# Access Compliance Report

## Public Rights-of-Way

### (Curb Ramps)

Intersection ID: 7091	Main Street: BROOKSHIRE_BV	Cross Street: HOVIS_RD	Location:	N
ADA ID: C21EA804E327	Ramp Type: Directional1	Initial Pass/Fail: Pass	Overall Compliance: No	Severity Score: 2.75
Codes/Mitigation Info/Possible Solution		Field Measurements/Component Compliance

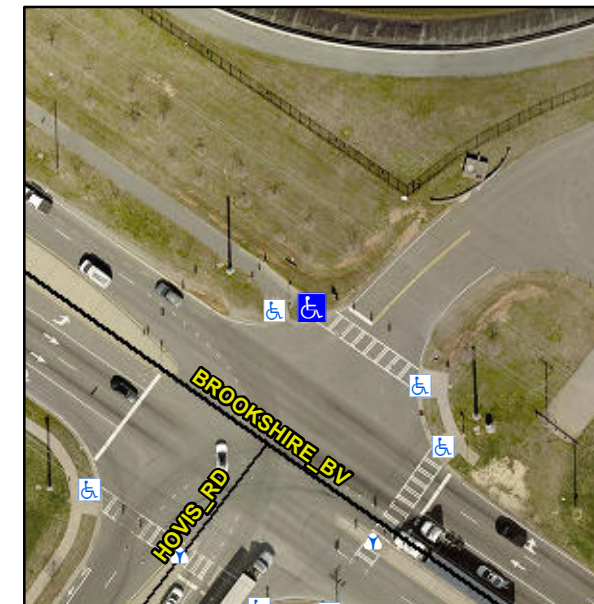
**NO CURB. DWS OS MEASURED TO ASP**

**R304.5.3, R305.1.4, R305.2**

Compliance	Description	Data	Compliance	Description	Data
N/A	Ramp Length (in)	24.0	Yes	Grade Break?	Yes
Yes	Ramp Width (in)	110.0	Yes	Grade Break Slope (%)	0.9
Yes	Ramp Slope (%)	0.9	No	Grade Break XSlope (%)	2.8
No	Ramp XSlope (%)	2.1			
N/A	Flare Type LT	N/A	N/A	Flare Type RT	N/A
N/A	Flare Slope LT (%)	N/A	N/A	Flare Slope RT (%)	N/A
N/A	Flare Traversable LT?	N/A	N/A	Flare Traversable RT?	N/A
Yes	Landing Length (in)	48.0	Yes	DWS Provided?	Yes
Yes	Landing Width (in)	110.0	Yes	DWS Contrast?	Yes
Yes	Landing Slope (%)	0.0	Yes	DWS Length (in)	24.0
No	Landing X Slope (%)	2.2	No	DWS Full Width?	No
N/A	Landing Curb? (Y/N)	No	No	DWS Offset LT (in)	12.0
N/A	Shared Landing?	No	No	DWS Offset RT (in)	73.0
Yes	Gutter Ponding?	No	Yes	Gutter Slope (%)	1.2
Yes	Gutter Lip Ht (in)	0.0	Yes	Gutter X Slope (%)	0.7
N/A	Painted X Walk1?	Yes		Road Slope (%)	1.1
	X Walk 1 Direction	To SE		Road X Slope (%)	1.3
	X Walk 1 Width (in)	111.0		Clear Space?	Yes

**Remove & Replace Entire Ramp.**
